Minor/Minor Site Review for New Detached Single Family Dwelling,

All Purpose Building Permit Application

CONSTRUCTION DETALLS

FOR DORMER

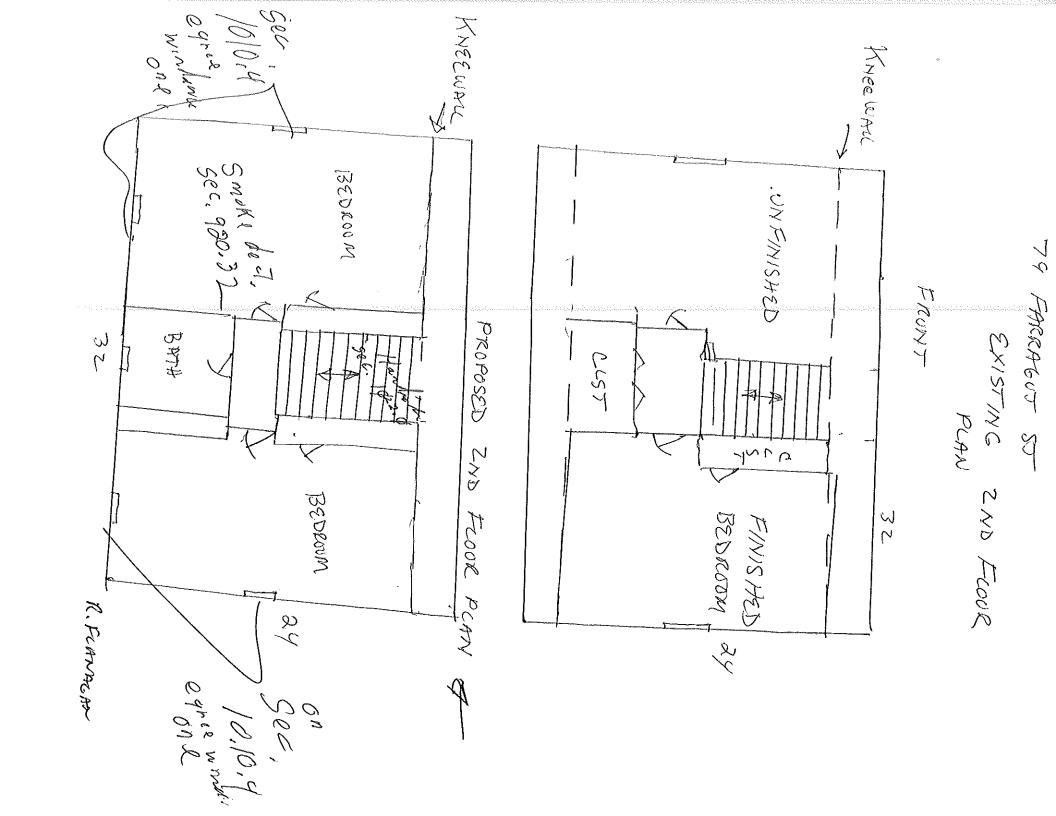
-	В	25ht is Not bema me	A TVX	マンナ のらく しゅっとりく しんのい してど	in Dormer construction is been Approved and I his best	,	ģ
	Ŋ	ħ		\	⊳		
	N)	片	ſ	3	b		
	b	┞.	1	P	3		
	6	۲	Ø	ľγ	[2		
i	h		2010	b	ľζ		1
	r	H	1	8	2	1	
		59	1200	ĥ	c	١	0
		5	K	Ľ	5	ľ	٠,
	C	1	ľ	3	_	1	1
		2	Н	K	3	۲.	
		6	H	Ľ	V		
	١.	H	×	Ç	B	1	
	Ì	Γ.	b	2,	. >		
		H	K	5	ξ	{	
		5	Ł	1		1	-
		r	12		<u>b</u>	Ŀ	(
١,		N	۲,	K	P E		
	١	ξ,	Ŕ	k	X		
		P	A	<i>[</i>]	P	ł	•
		18	L	1,	\checkmark
